UNITED STATES PATENT AND TRADEMARK OFFICE

APPLICATION NO.	FILING DATE	FIRST NAMED INVENTOR	ATTORNEY DOCKET NO.	CONFIRMATION NO.
09/752,191	12/29/2000	Jeffrey L. Cornell	PDY-100-A	8148

Office Action Summary

DETAILED ACTION

Fig. 2

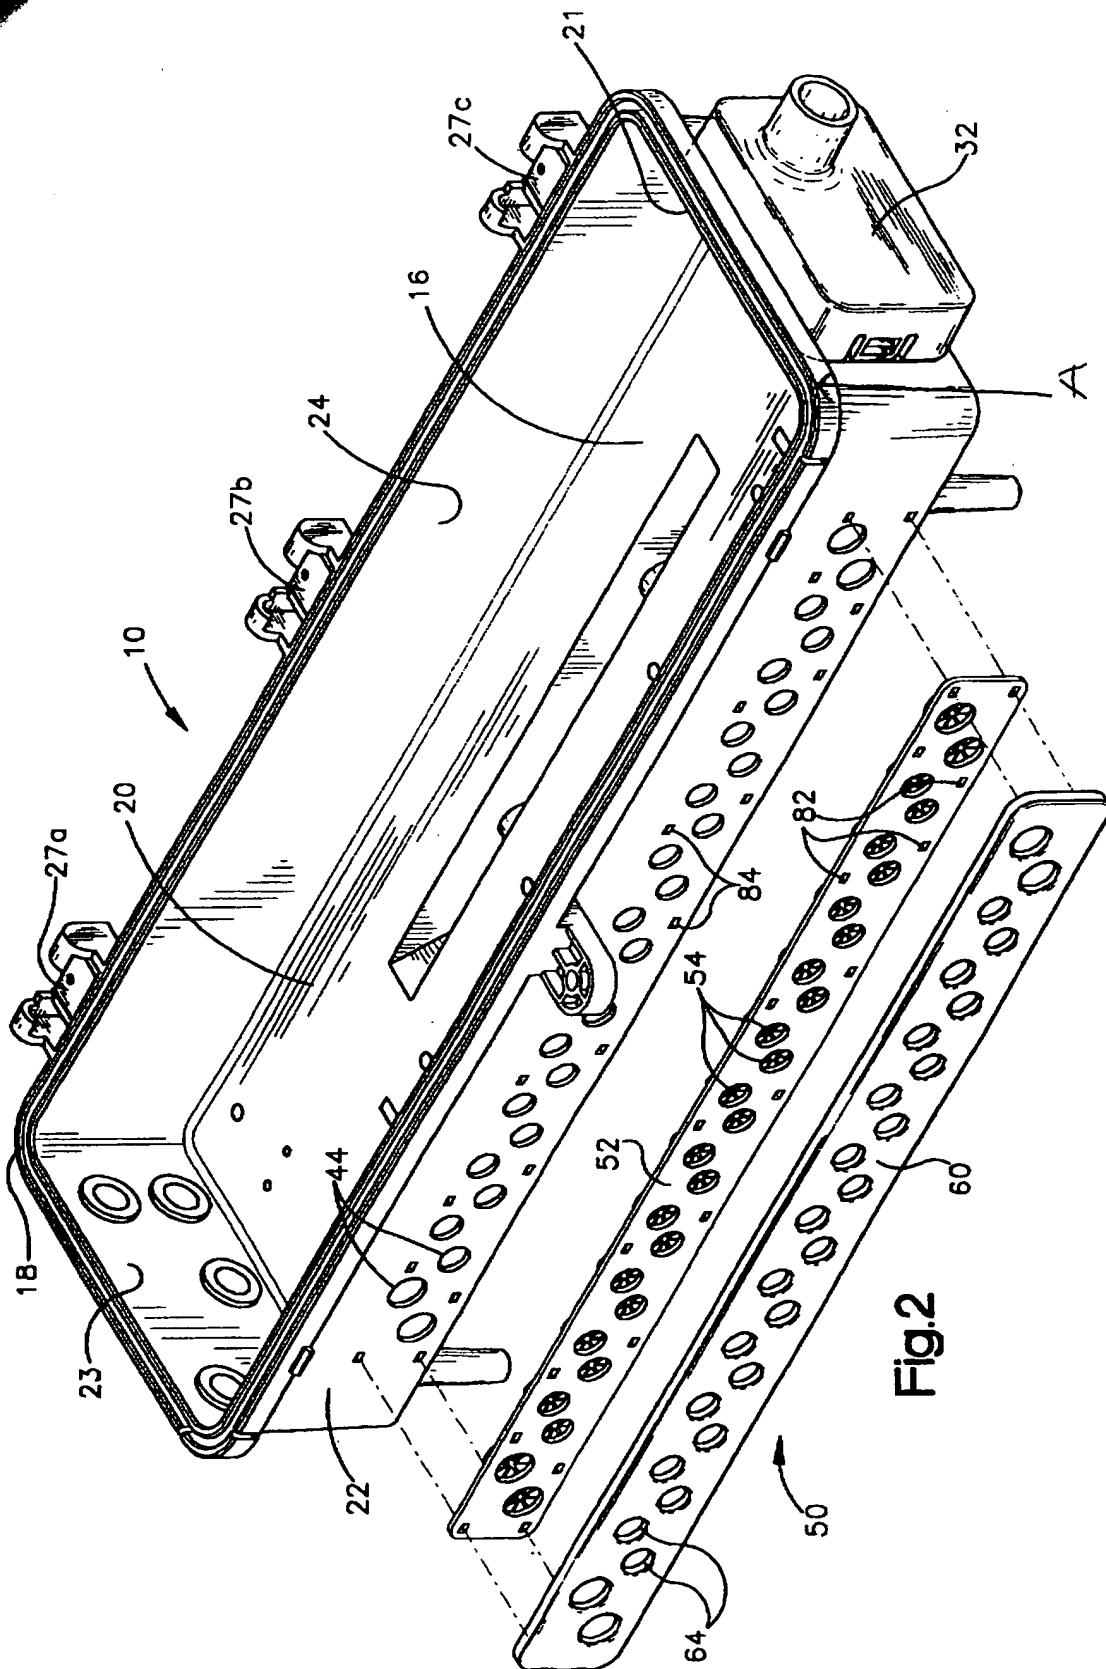
Farr et al., figure 2, disclose an enclosure (10) having (A, attached sheet) which is read as a flange. It would have been obvious to one of ordinary skill in the art at the time the invention was made to have the flange as taught by Farr et al., in order to secure the member into the housing.
